Identification cards — Test methods —

Proximity cards

**AMENDMENT 4: Additional test methods for
PCD RF interface and PICC alternating field
exposure**

Amendment 4 to ISO/IEC 10373-6:2001 was prepared by Joint Technical Committee ISO/IEC JTC 1, *Information technology*, Subcommittee SC 17, *Cards and personal identification*.

Figure 1 — ESD test circuit

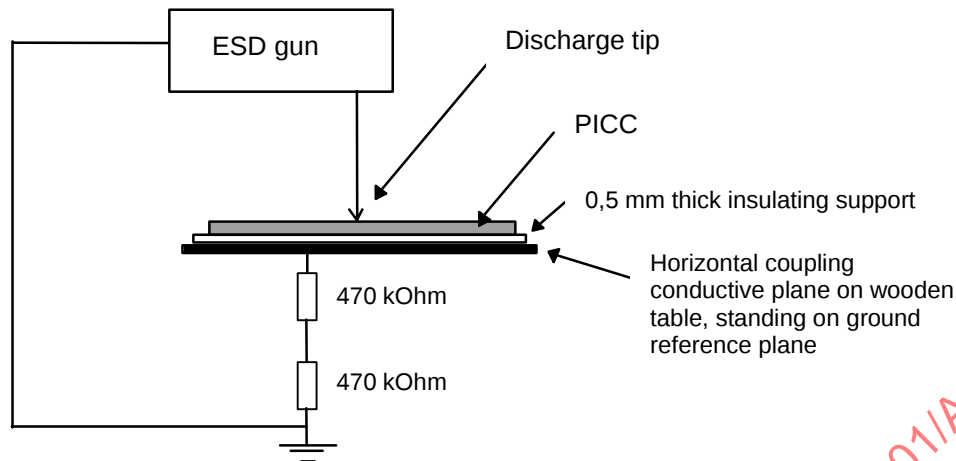
Pages 3 and 4, Clause 5

Replace Clause 5 and subclauses 5.1, 5.2 and 5.3 with the following:

The purpose of this test is to check the behaviour of the card IC in relation to electrostatic discharge (ESD) exposure in the test sample. The PICC under test is exposed to a simulated electrostatic discharge (ESD, human body model) and its basic operation checked following the exposure.

5.3.1 Apparatus

Refer to IEC 61000-4-2:1995.

a) Main specifications of the ESD generator:

- energy storage capacitance: $150 \text{ pF} \pm 10 \%$;
- discharge resistance: $330 \Omega \pm 10 \%$;
- charging resistance: between $50 \text{ M}\Omega$ and $100 \text{ M}\Omega$;
- rise time: $0,7 \text{ ns}$ to 1 ns .

b) Selected specifications from the optional items:

- type of equipment: table top equipment;
- discharge method: direct application of air discharge to the equipment under test;
- discharge electrodes of the ESD generator: round tip probe of 8 mm diameter.

Figure 2 — Test zones on PICC for ESD test

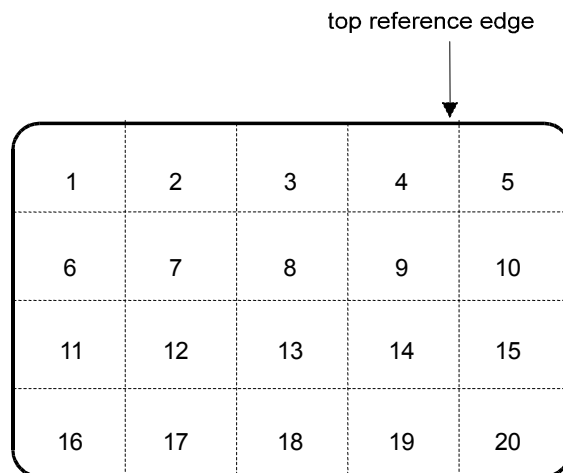
Apply the discharge successively in normal polarity to each of the 20 test zones shown in Figure 2. Then repeat the same procedure with reversed polarity. Allow a cool-down period between successive pulses of at least 10 s .

5.3.2 Test procedure

Connect the ground pin of the apparatus to the conductive plate upon which the PICC is placed.

WARNING — If the PICC includes contacts, the contacts should face up and the zone which includes contacts should not be exposed to this discharge.

Check that the PICC operates as intended at the end of the test.
